**Zoning Ordinance Approval
CITY OF AUSTIN
RECOMMENDATION FOR COUNCIL ACTION**

SUBJECT: C814-90-0003.13 - Harris Branch PUD Amendment #13 - Approve second/third readings of an ordinance amending Chapter 25-2 of the Austin City Code by rezoning property located at 1375 U.S. Highway 290 East at Proposed State Highway 130 (Harris Branch, Gilleland Creek, Decker Creek Watersheds) from planned unit development (PUD) district zoning to planned unit development (PUD) district zoning to change a condition of zoning. First reading approved on October 27, 2005. Vote: 6-0, Council Member Alvarez off the dais. Applicant: Austin HB Residential Properties (John McCullough). Agent: Minter, Joseph & Thornhill, P.C. (John M. Joseph). City Staff: Sherri Sirwaitis, 974-3057.

ZONING CASE NUMBER: C814-90-0003.13

P.U.D. LAND USE PLAN

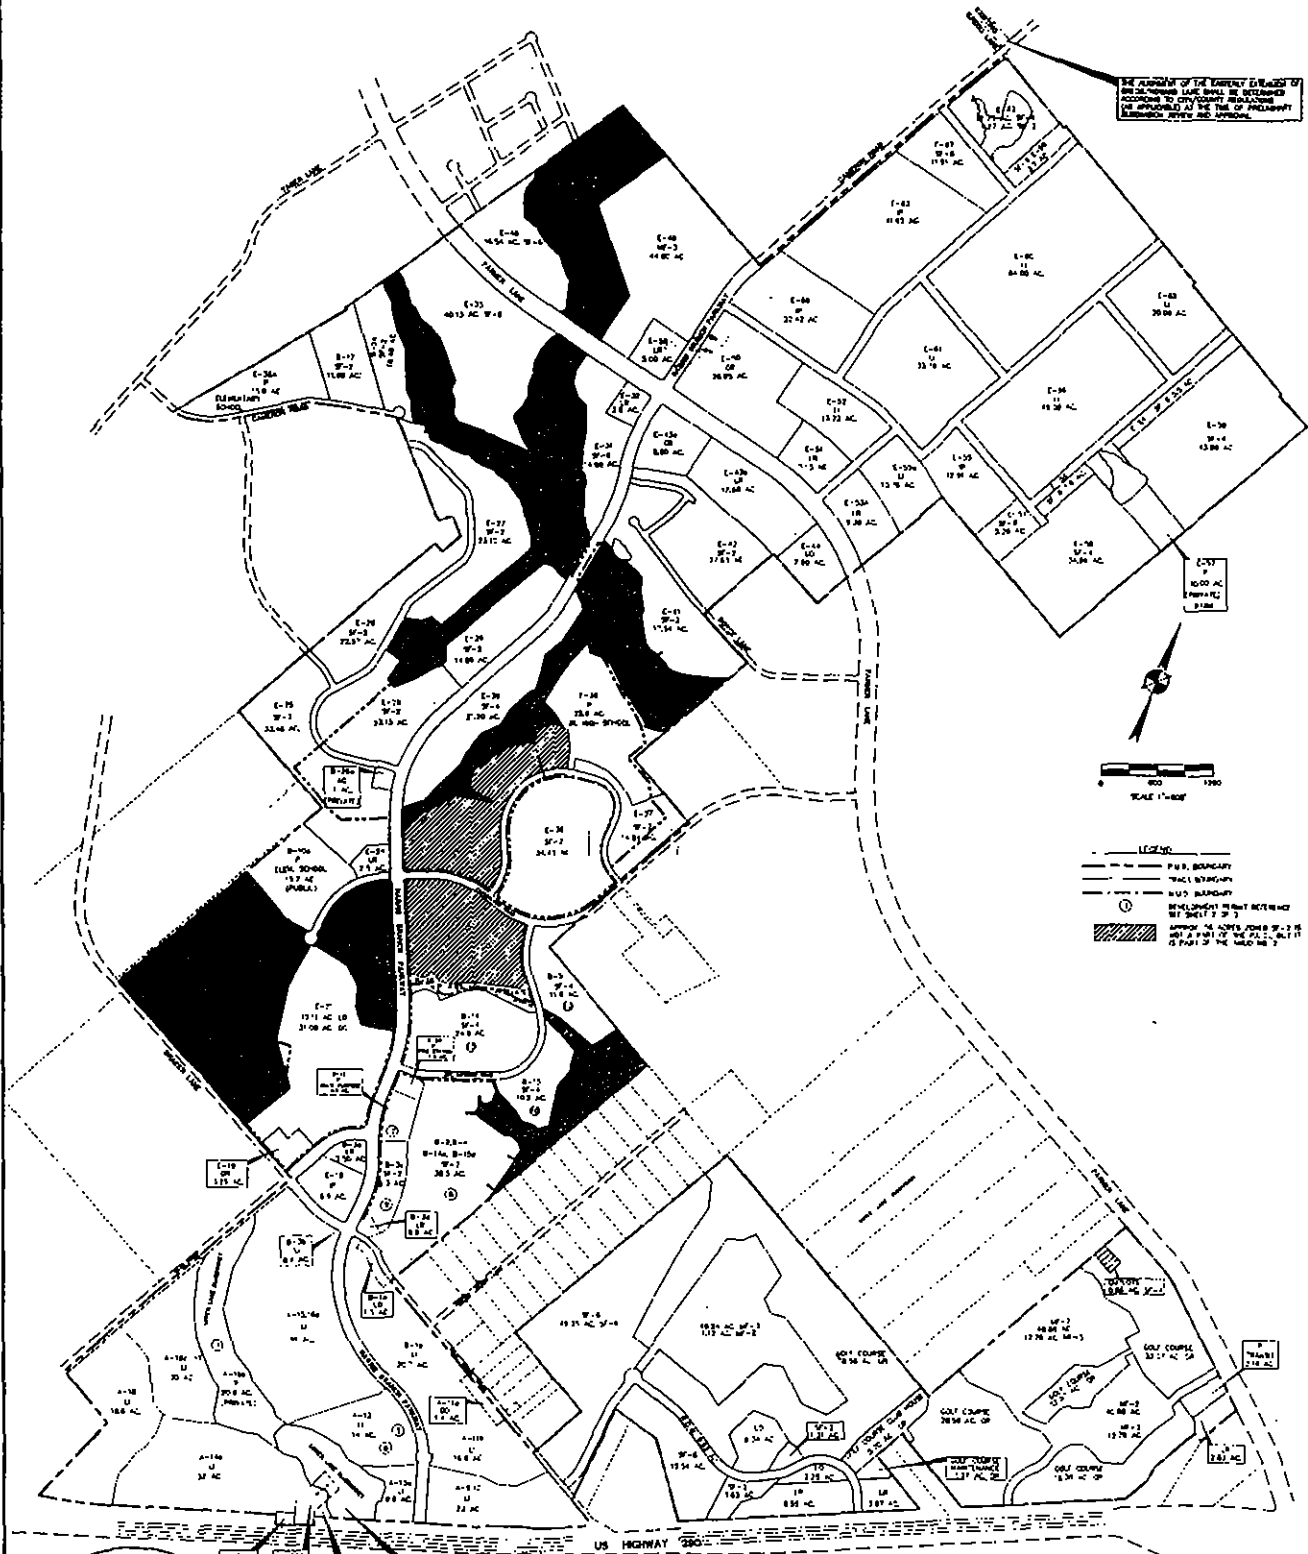
It is difficult to tell on sheet 2 of the PUD plan what has changed, since Revision 13 is with 11 & 12, and the changes were not clouded.

Please redline the approved Harris Branch PUD Land Use Plan to directly show the proposed changes for the PUD. Please redline the PUD Densities Tables - Sheet 2 to display how the proposed revisions to Tracts SG-1 through SG-14 will affect the breakdown of uses and within the PUD. Please provide information concerning the how the proposed land use changes will affect the overall building coverage and impervious cover amounts within the PUD.

ZN-2 The Harris Branch PUD Land Use Plan has a "red line" drawn around the areas subject to this amendment. Attached Please see the revised Harris Branch Density Tables -- Sheet 2 showing the effect on building coverage and impervious cover.
